Addendum No.[2]

Project Name:	Mt. Hope School – New Build
		Project No.:	221125-140
		Architect:	C2AE
		Date:	7/27/2023
Bid Package No.:	2		-
Bid Due Date:	08/03/2023		_

This Addendum is issued to inform the bidders of modifications in the scope of work being bid for this project.

Typ. Exterior Wall Base Detail @ Storefront REVISED ADDENDUM 2

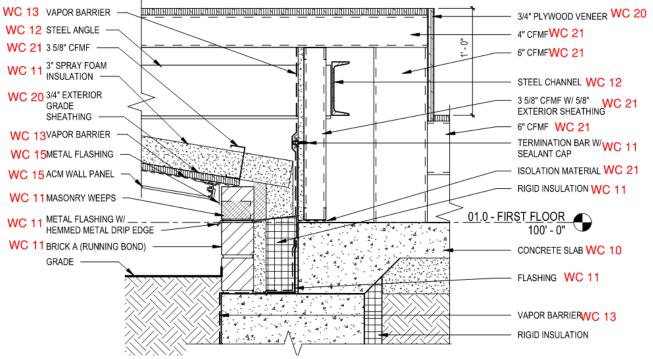
- Added Specific Note and Detail #2
 - Provide and install all waterproofing at showers for a complete installation.
- Scope Clarification Diagrams
 - Removed WC I I Rigid Insulation responsibility in Typ. Exterior Wall Base
 Detail @ Storefront at Concrete Footing
 - Added WC 10 Rigid Insulation responsibility in Typ. Exterior Wall Base Detail @ Storefront at Concrete Footing
 - Removed WC 13 Waterproofing responsibility in Shower Pan Detail
 - Added WC 22 Waterproofing responsibility in Shower Pan Detail
- Bid Form
 - O Added alternate #4 to mandatory alternates.
- RFI Questions & Answers (to date).
- Prebid Meeting Agenda.
